Service Letter No. 256

SUBJECT: Heater Fuel Shut-Off Valve

MODELS AFFECTED: PA-23 Apaches, serials 23-1 to 23-295 inclusive; 23-297, 23-299 to 23-303 inclusive; 23-305 to 23-308 inclusive and 23-317.

HEATER FUEL SHUTOFF VALVE	
SKETCH "H"	LETTER #256
PIPER AIRCRAFT CORP.	
LOCK HAVEN, PA.

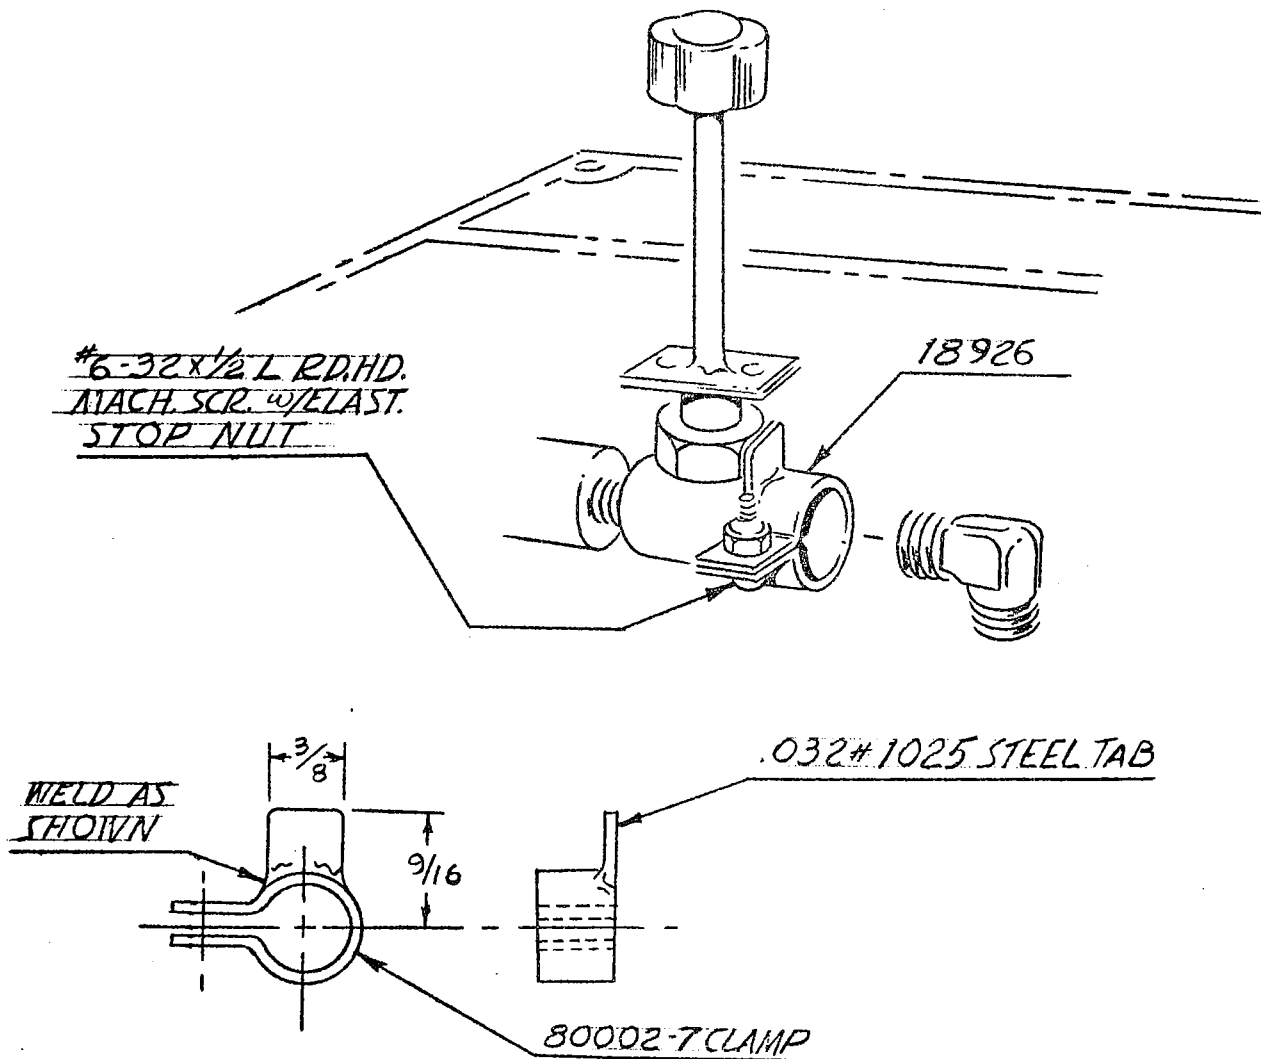
We have been experiencing a little trouble with the packing nut on the heater fuel shut-off valve working loose during valve operation. A safety clamp, Part No. 18926-00, has been devised and is now being installed on all new production airplanes.

It is suggested that this clamp be installed, per the sketch on the reverse side of this letter, whenever it becomes necessary to remove the bottom access panel on the fuselage for any other reason. Clamp, Part No. 18926-00 can be obtained through your nearest Piper distributor or dealer on a No Charge basis.

1. Remove large access panel from bottom of fuselage directly beneath front spar.
2. Spread clamp (18926-00) and place over heater fuel shut-off valve as shown. (Valve is located in fuel control box directly forward of front spar at center line of airplane.) Make certain lug of clamp is firmly against packing nut of valve before tightening machine screw and elastic stop nut on clamp.
